Sling Aircraft (Pty) Ltd
Registration no 2002/022837/07
Approved Maintenance Organisation AMO1264
Manufacturing Organisation M677

SERVICE BULLETIN

#0020 Revision 1

SUBJECT: Eyebolt inspection and conditional replacement

Figure 16: Flap Controls

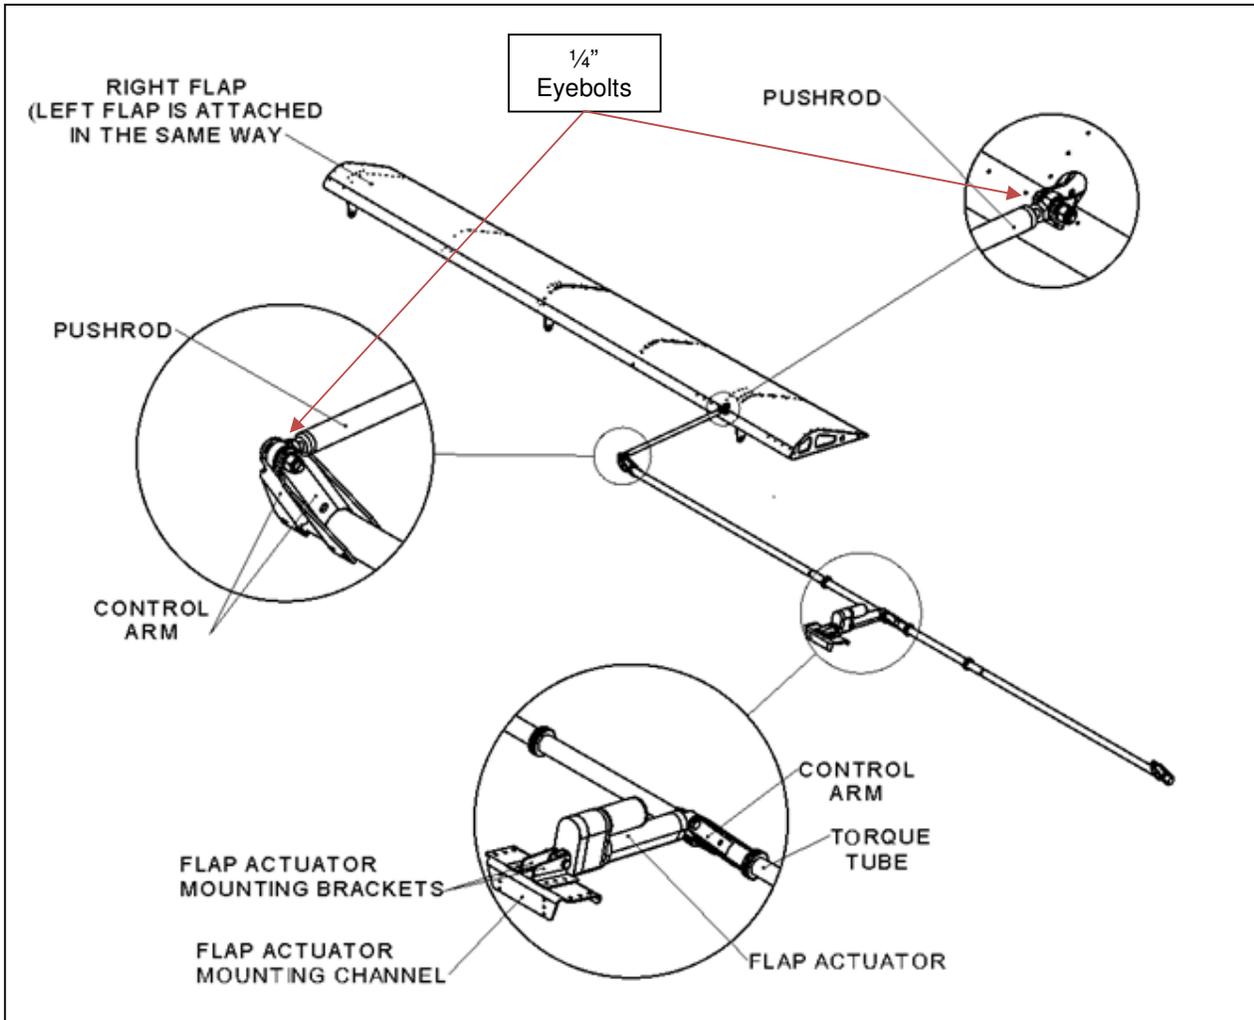
The eyebolts used in the flap control assembly can be seen in Figure 16. These can be inspected using the inspection hatches located on the wing. Due to symmetry only one flap has been shown. The same eyebolts will be found on the other side of the aircraft. The eyebolts need to be inspected and replaced where *noncompliant eyebolts* have been installed.

- Step 2. The eyebolt can then be replaced with a *type 1* or *type 2* eyebolt if required.
 Step 3. Reverse the procedure in Step 1, to reinstall the eyebolts in the flap's leading edge.

Step 5. The eyebolt can then be replaced with a *type 1* or *type 2* eyebolt if required.

Figure 17: Sling 2 and Sling LSA elevator control system

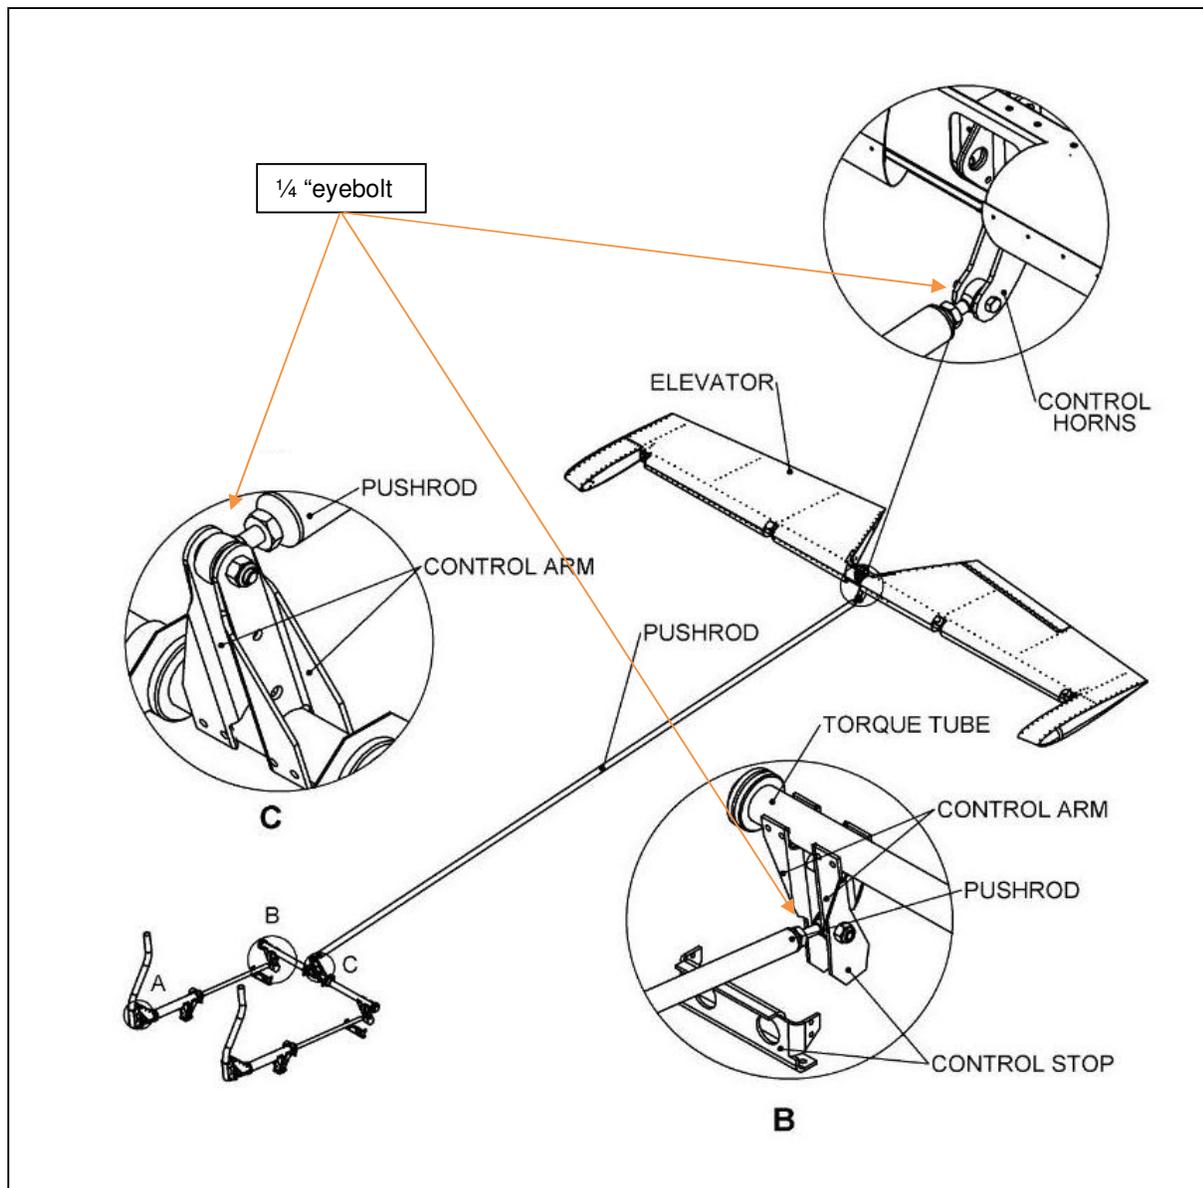
This section is only applicable to the Sling 2 and Sling LSA. The eyebolts used in the Sling 2 and Sling LSA elevator controls can be seen in Figure 17.

- Step 1. Ensure the seats and control covers have been removed, as stated in Section 3.2.2.
- Step 2. Inspect the eyebolts seen in Detail C of Figure 17. An exploded view of Detail C can be seen in Figure 18.

Figure 18: Eyebolt assembly, Detail C

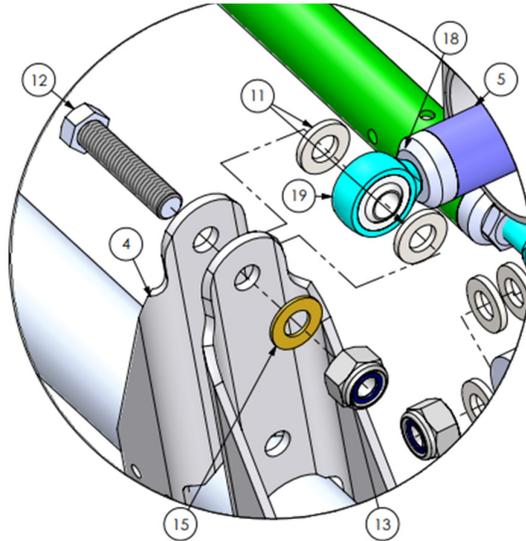
- Step 3. Refer to Figure 18. If a *noncompliant* eyebolt has been used, it must be replaced (with either a *type 1* or *type 2*). To do this, remove the AN4 locknut (13) and bolt (12). The eyebolt can now be uninstalled from the pushrod and a new one can be installed.
- Step 4. Once the new eyebolt has been installed onto the pushrod, reconnect the eyebolt assembly. Refer to Figure 18 for part layout.
- Step 5. Next, the eyebolts seen in Detail B of Figure 17 will need to be inspected and replaced if found to be *noncompliant*.
- Step 6. An enlarged view of Detail B can be seen in Figure 19.

Figure 19: Enlarged view of eyebolt assembly of Detail B

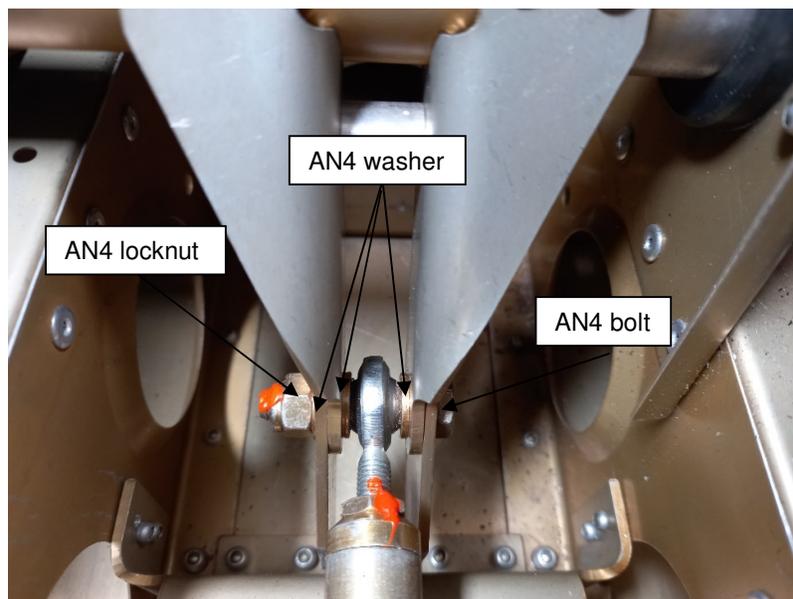
- Step 7. Refer to Figure 19 and remove the locknut and bolt.
- Step 8. Replace the *noncompliant* eyebolt with a *type 1* or *type 2*.
- Step 9. Reinstall the components, as shown in Figure 19.
- Step 10. Repeat Step 7 to Step 9 for the corresponding eyebolt assembly on the other side of the aircraft.

Figure 20

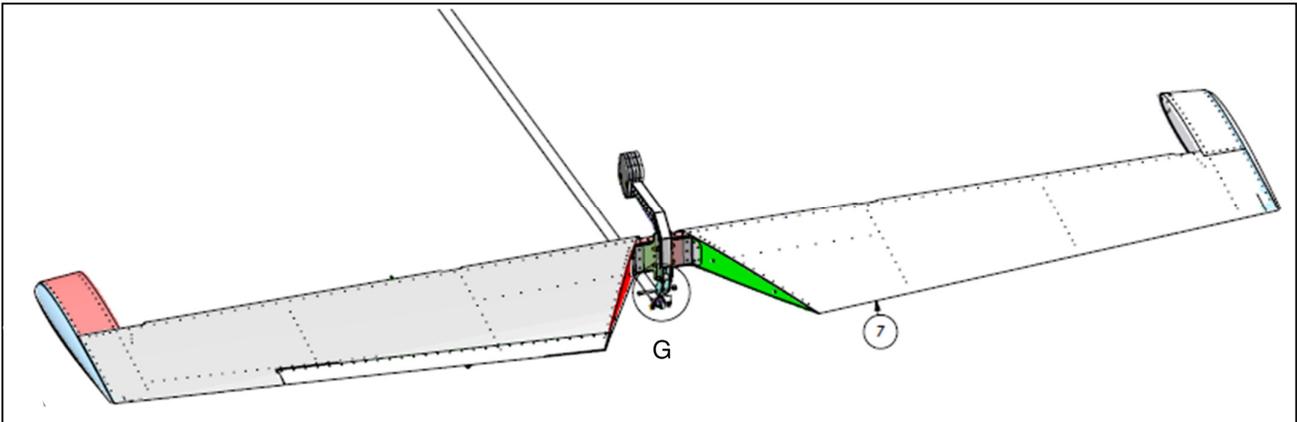
Step 11. The last eyebolt that needs to be inspected and replaced is the one connected to the elevator horn in detail G of Figure 20.

Figure 22: Detail G

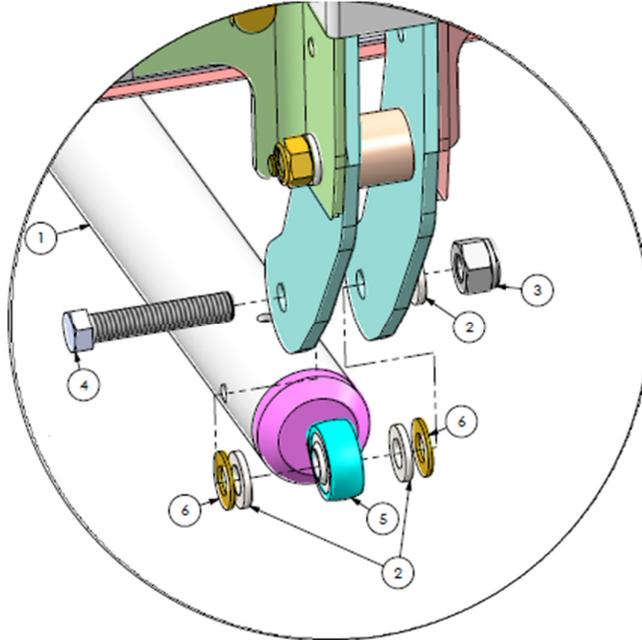
Step 13. Remove the AN4 locknut (3) and bolt (4), shown in Figure 22.

- Step 14. Replace the *noncompliant* eyebolt (5) with either a *type 1* or *type 2*.
 Step 15. Reassemble the eyebolt assembly as seen in Figure 22.
 Step 16. You will need to adjust the elevator once the new eyebolts are installed to ensure correct elevator deflection. To do this follow the instructions in the applicable MAM shown in the table below:

Figure 23

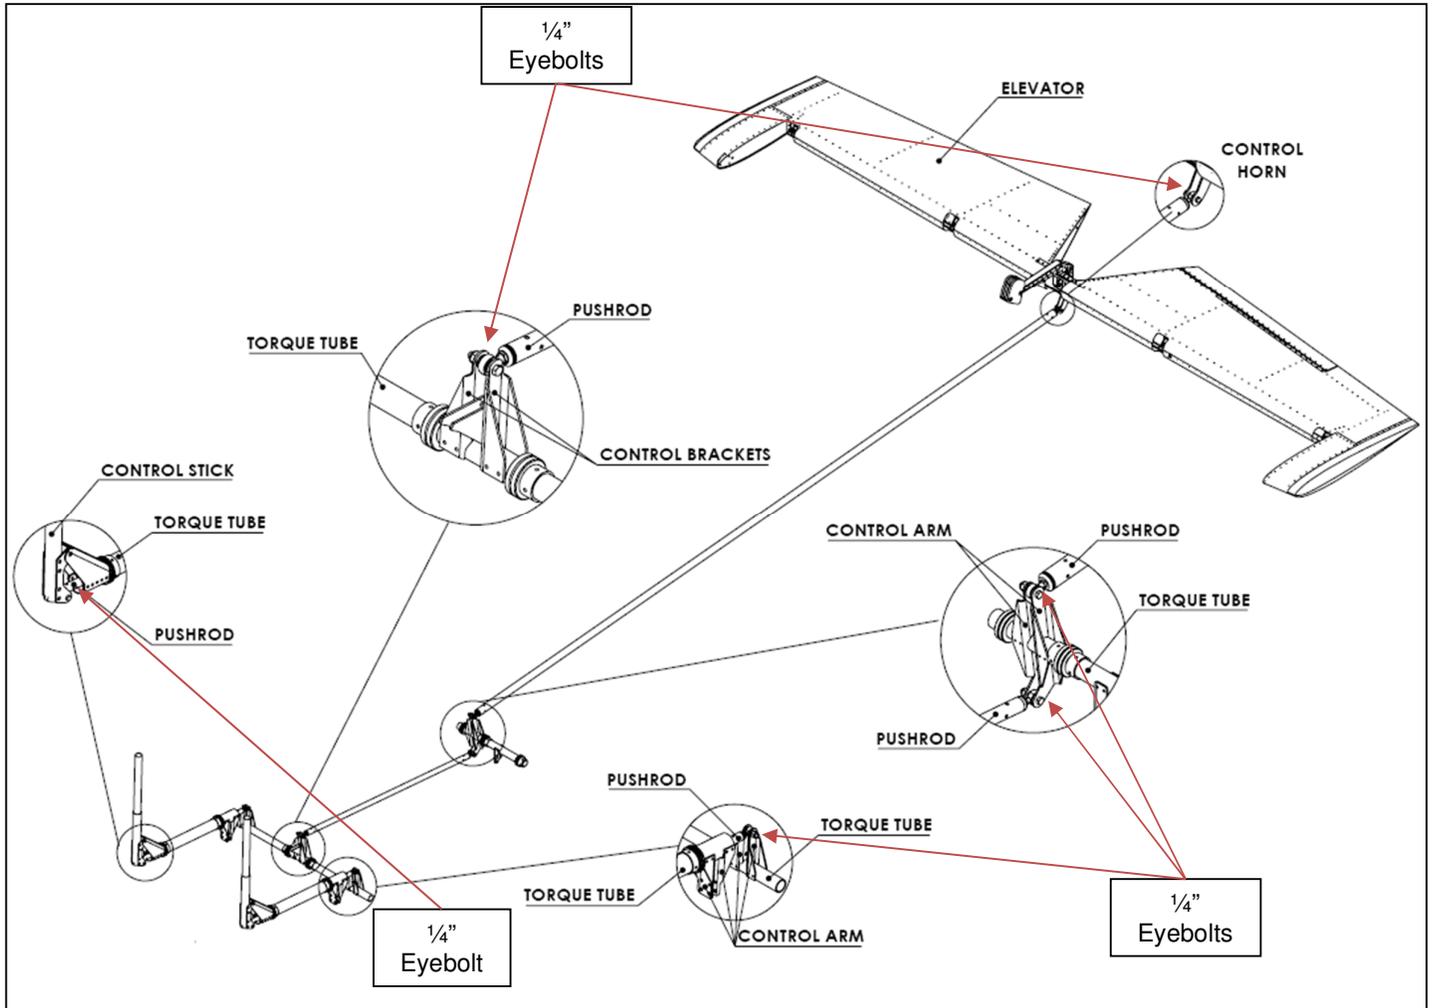
This section is only applicable to the Sling 4 and Sling 4 TSi. The eyebolts used in the elevator controls can be seen in Figure 23. The eyebolts need to be inspected and replaced where *noncompliant* eyebolts have been installed.

Figure 24: Eyebolt assembly, Detail A

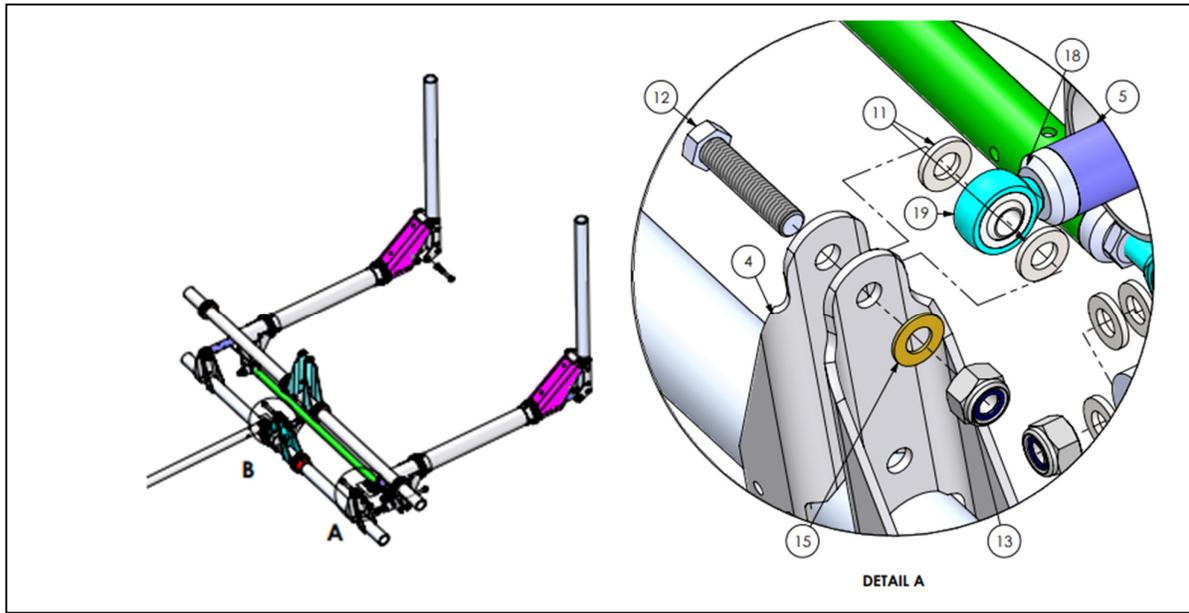
- Step 3. If *noncompliant* eyebolts have been used, they must be replaced (with either *type 1* or *type 2*). To do this remove the AN4 locknut (13) and bolt (12), as seen in Figure 24. The eyebolt can now be uninstalled from the pushrod. Once uninstalled, install a new one of either *type 1* or *type 2*.
- Step 4. Once the eyebolt has been installed onto the pushrod, reconnect the eyebolt assembly. Refer to Figure 24 for the way the assembly fits together.
- Step 5. Next inspect the eyebolts seen in Detail B of Figure 25.

Figure 25: Eyebolt assembly, Detail B

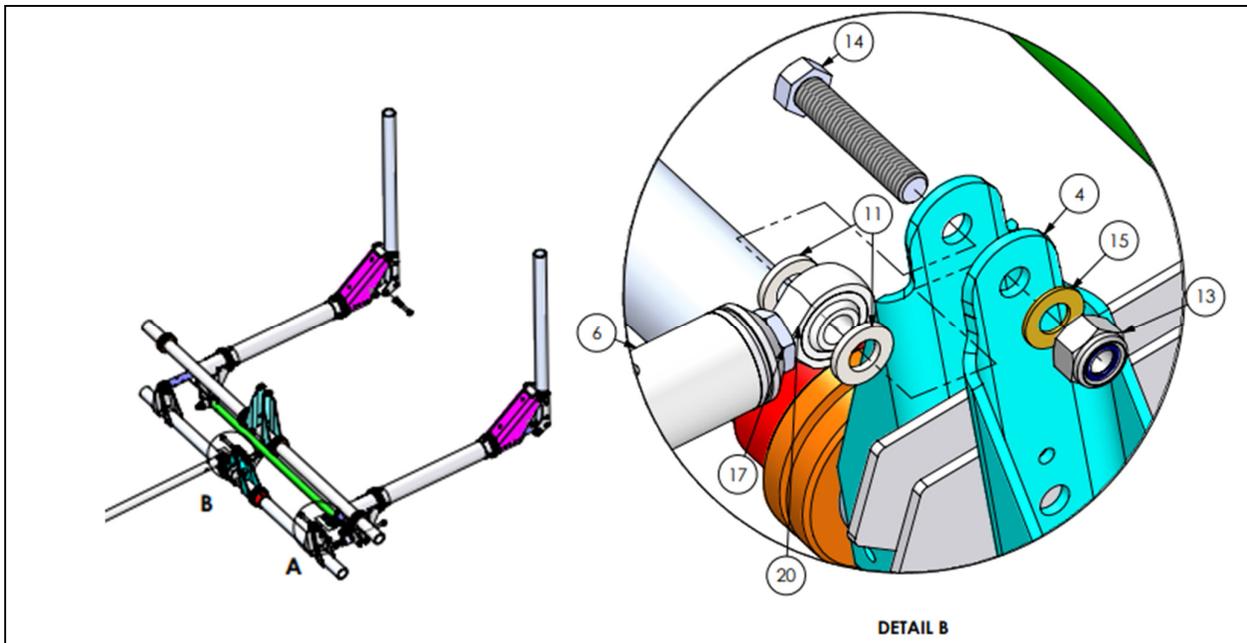
- Step 6. Remove the AN4 locknut (13) and bolt (14), as seen in Figure 25. Once removed the eyebolt can be uninstalled and an eyebolt of *type 1* or *type 2* can be reinstalled.
- Step 7. Reassemble the eyebolt assembly, refer to Figure 25 for part placement.

Figure 26

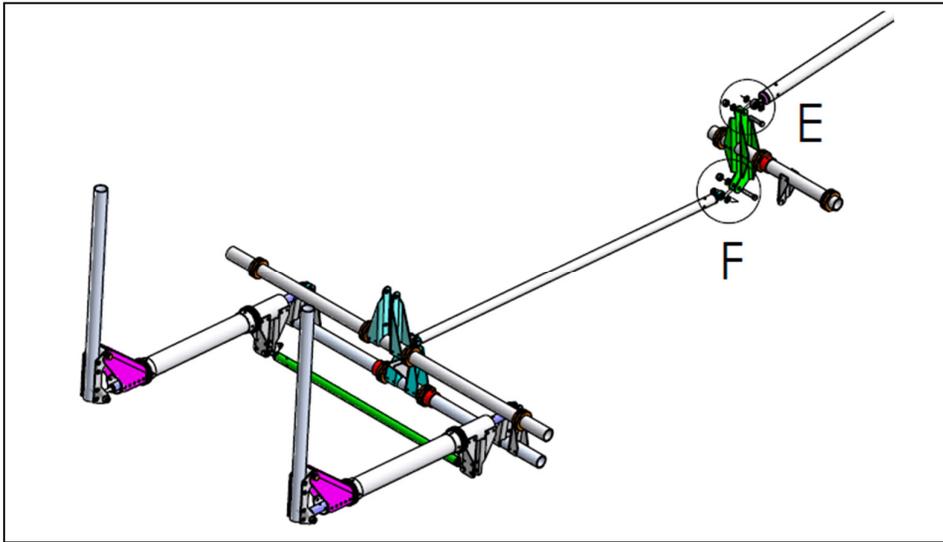
Step 8. Next, the eyebolts seen in Detail E and F in Figure 26 will need to be inspected and replaced if found to be of *noncompliant*. To access these in the Sling 4 TSi, remove the rear seats. To do this follow the instructions in the applicable MAM shown in the table below:

Figure 27: Eyebolt assembly, Detail E

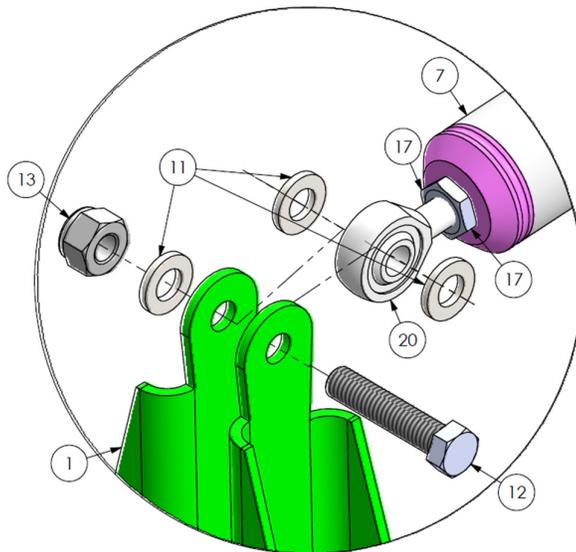
Step 9. To replace the eyebolt seen in Figure 27, remove the AN4 locknut (13) and bolt (12). Replace the *noncompliant* eyebolt (20) with either a *type 1* or *type 2* eyebolt.

Step 10. Once the eyebolt has been replaced, reassemble the eyebolt assembly. Refer to Figure 27 for component positions.

Figure 28: Eyebolt assembly, Detail F

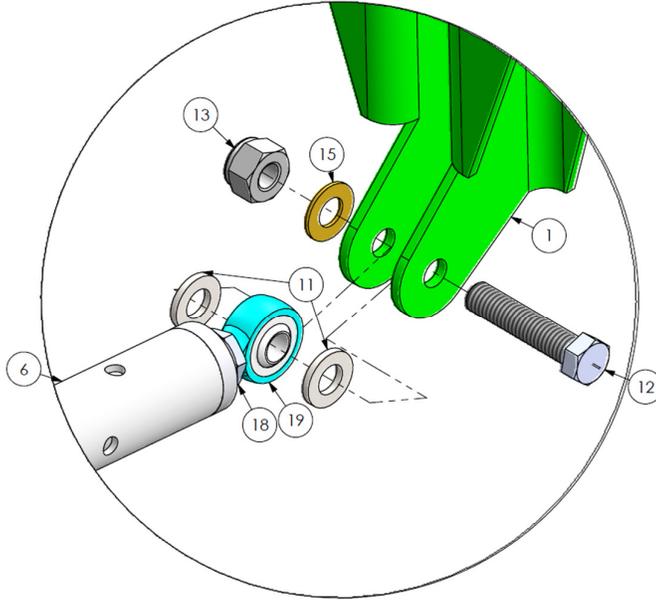
Step 11. To replace the eyebolt seen in Figure 28, remove the AN4 locknut (13) and bolt (12). Replace the *noncompliant* eyebolt with either a *type 1* or *type 2* eyebolt.

- Step 12. Once the eyebolt has been replaced, reconstruct the eyebolt assembly. Refer to Figure 28 for component layout.
- Step 13. The last eyebolt that needs to be inspected and replaced is the one connected to the elevator horn, located in detail G of Figure 29.

Figure 31: Detail G, exploded view

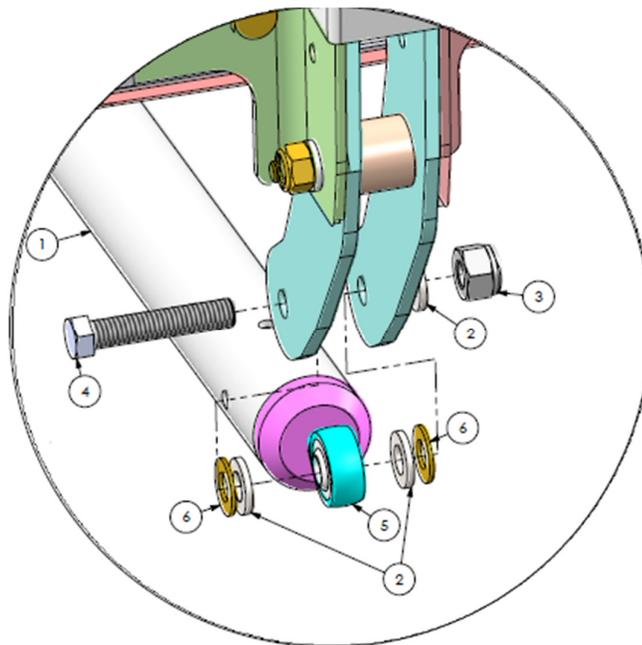
Step 15. Remove the AN4 locknut (3) and bolt (4), shown in Figure 31.

Step 16. Replace the eyebolt (5) with either a *type 1* or *type 2*.
